Access Compliance Report

Public Rights-of-Way

(Curb Ramps)

Intersection ID: 19683	Main Street: CARNEGIE_BV	Cross Street: CONGRESS_ST	Location: SW
ADA ID: 39C808F6A846	Ramp Type: PerpDiag	Initial Pass/Fail: Fail	Overall Compliance: No
Severity Score: 22.5			
Codes/Mitigation Info/Possible Solution		Field Measurements/Component Compliance

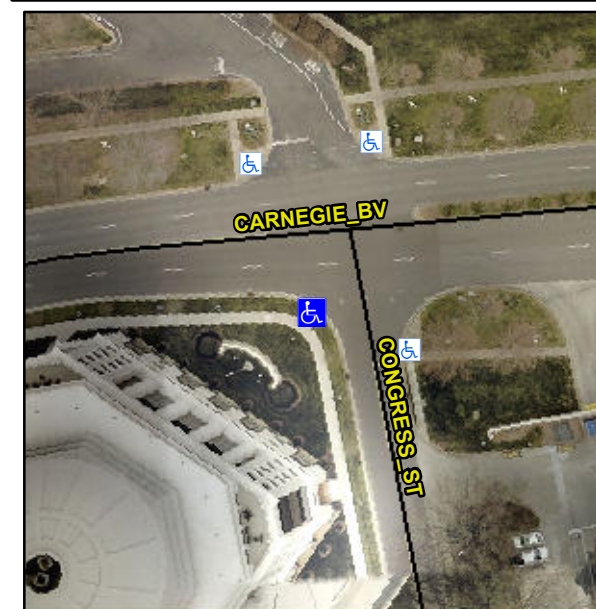
Not Found, R304.5.1, R304.2.2, R304.5.3

Compliance	Description	Data	Compliance	Description	Data
N/A	Ramp Length (in)	97.0	No	Ramp Slope (%)	9.7
No	Ramp Width (in)	47.5	No	Ramp XSlope (%)	2.4
N/A	Flare Type LT	N/A	N/A	Flare Type RT	N/A
N/A	Flare Slope LT (%)	N/A	N/A	Flare Slope RT (%)	N/A
N/A	Flare Traversable LT?	N/A	N/A	Flare Traversable RT?	N/A
N/A	Landing Length (in)	N/A	N/A	DWS Provided?	N/A
N/A	Landing Width (in)	N/A	N/A	DWS Contrast?	N/A
N/A	Landing Slope (%)	N/A	N/A	DWS Length (in)	N/A
N/A	Landing X Slope (%)	N/A	N/A	DWS Full Width?	N/A
N/A	Landing Curb? (Y/N)	N/A	N/A	DWS Offset (in)	N/A
N/A	Shared Landing?	N/A			
N/A	Gutter Ponding?	N/A	N/A	Gutter Slope (%)	N/A
N/A	Gutter Lip Ht (in)	N/A	N/A	Gutter X Slope (%)	N/A
N/A	Painted X Walk1?	No	N/A	Painted X Walk2?	No
	X Walk 1 Direction	To SE		X Walk 2 Direction	To N
N/A	X Walk 1 Width (in)	N/A	N/A	X Walk 2 Width (in)	N/A
	X Walk 1 Slope (%)	2.3		X Walk 2 Slope (%)	1.8
	X Walk 1 X Slope (%)	3.2		X Walk 2 X Slope (%)	1.3

Remove & Replace Curb Ramp With Two New Directional Ramps or Equivalent.
